## **REMARKS**

Claims 1 through 72 are pending in the application. Claims 1, 5 through 10, 14 through 19, 23 through 27, 38, 49 and 60 have been amended. Claims 70 through 72 are newly added. Reconsideration of this application is respectfully requested.

FIG. 11

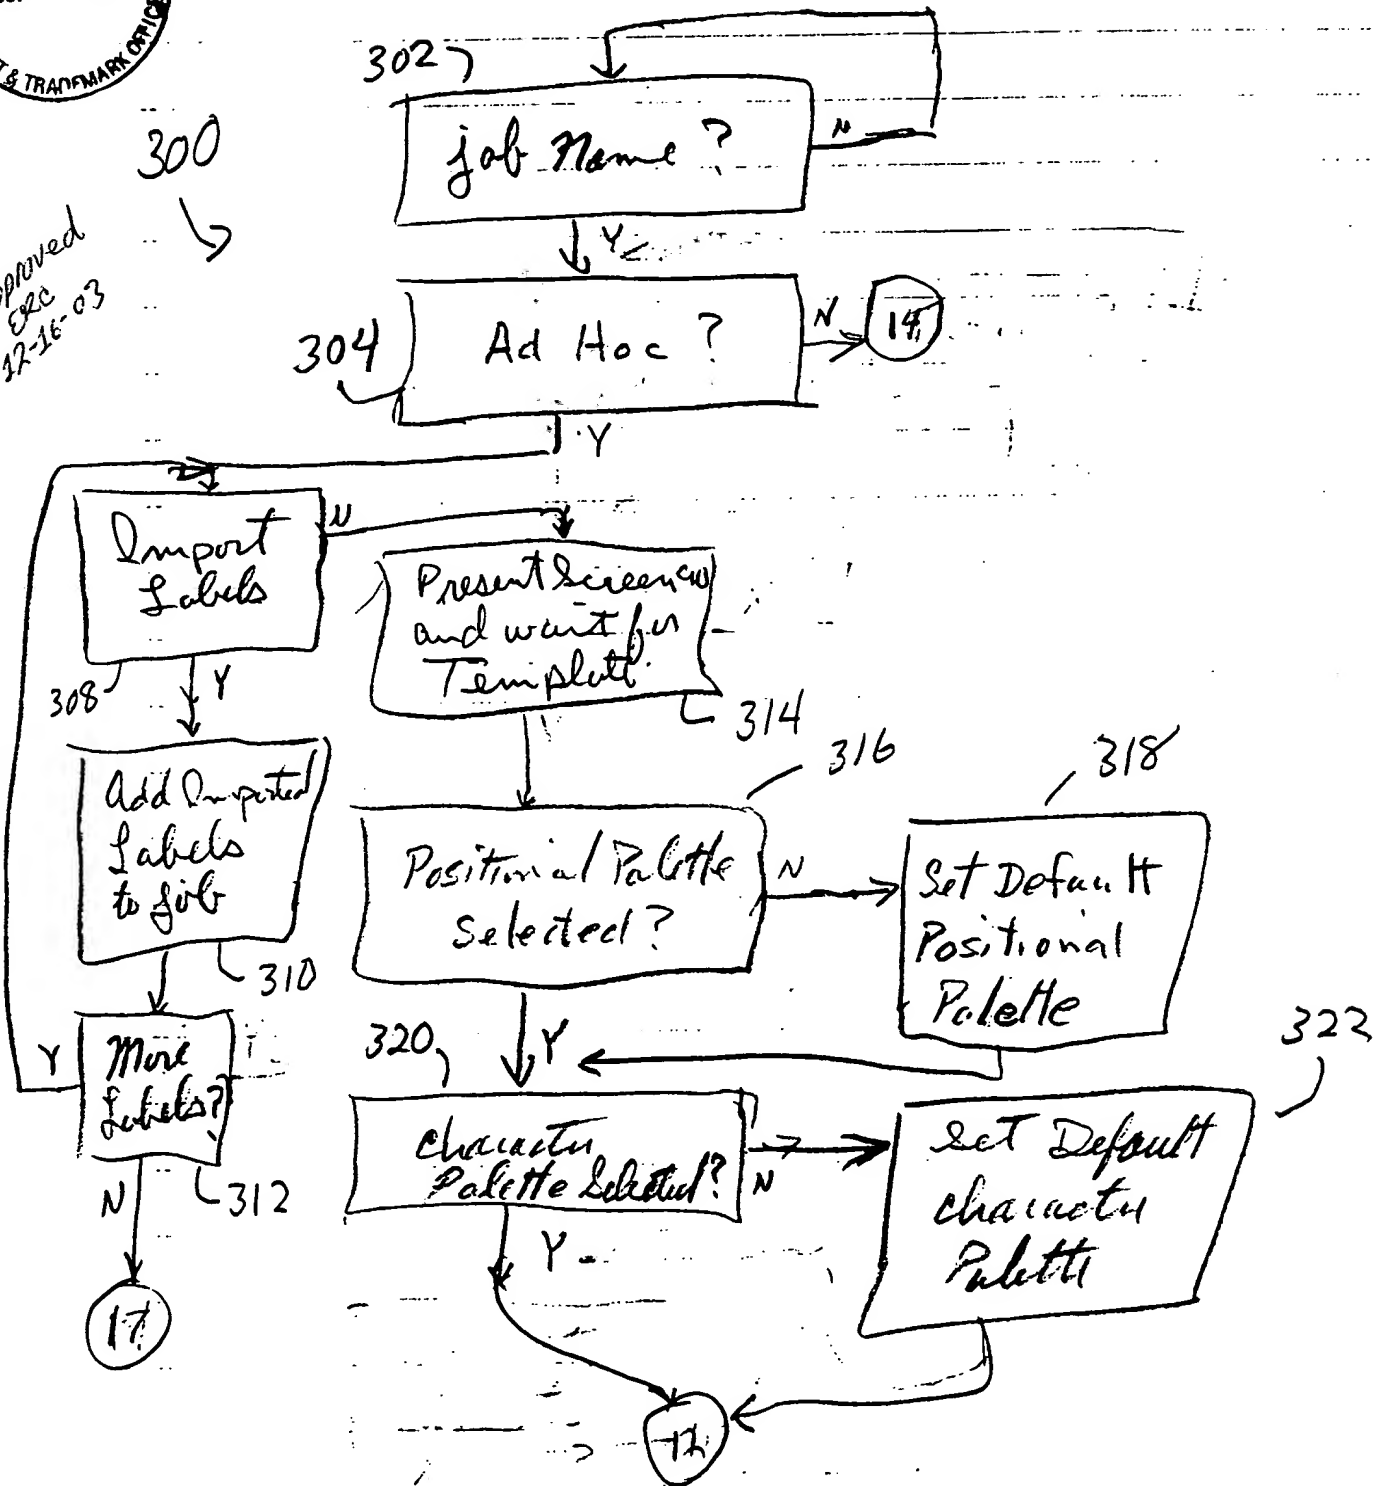
The Office Action has objected to the drawing on the ground that Figs. 11, 12, 13 and 17 lack certain Y or N legends as detailed at pages 2 and 3 of the Office Action. Replacement drawing sheets containing proposed revisions to Figs. 11, 12, and 17 are attached hereto for the Examiner's approval. Thus, Fig. 11 has been amended by supplying a "Y" for step 304. Fig. 12 has been amended by supplying "Y" and "N" legends for step 342. Fig. 17 has been amended by supplying "Y" legends for steps 452 and 464.

FIG. 16

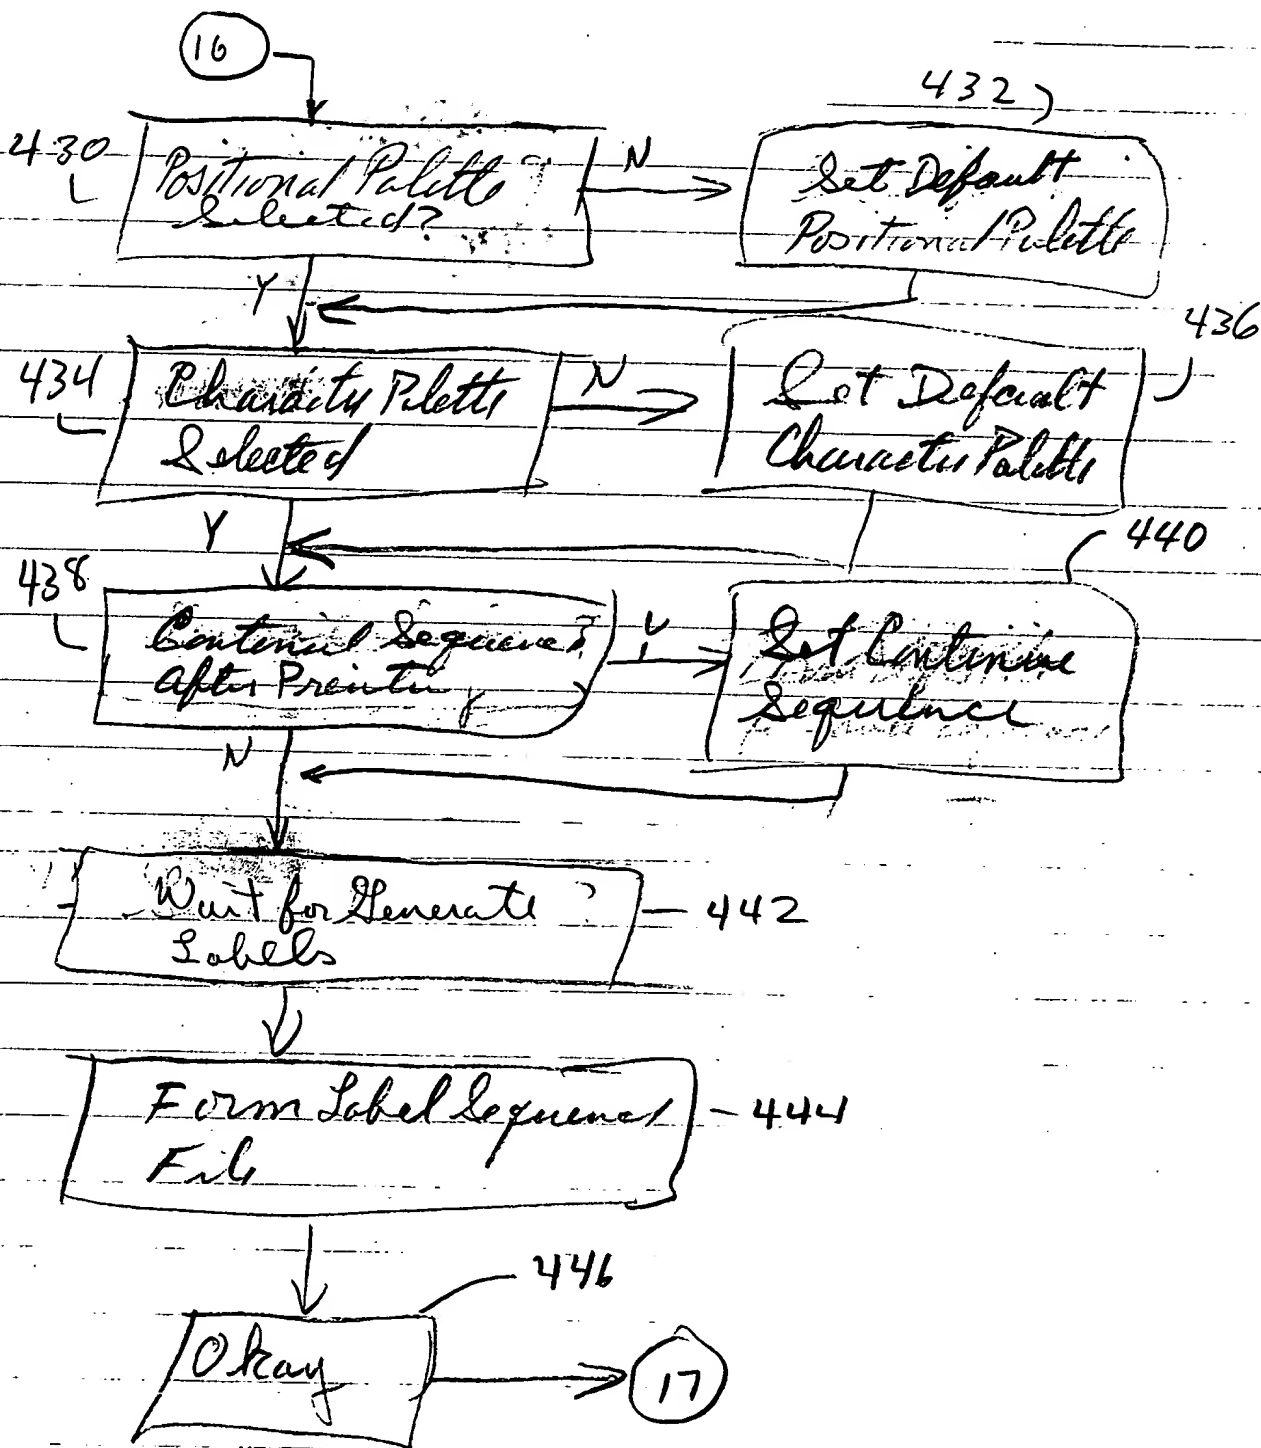
With respect to the objection to Fig. 16, the specification has been amended at page 16 to provide a description that is consistent with Fig. 16. A replacement drawing sheet is also attached that contains a proposed revision to Fig. 16 for the approval of the Examiner. Fig. 16 has been amended to change step 432 to read "Set Default Positional Palette" in stead of "Record Selected Positional Palette". Support for this change is found in the original specification at page 16, line 6. Fig. 16 has also been amended to add a "Y" legend at step 434 and to delete a "Y" legend at step 442.
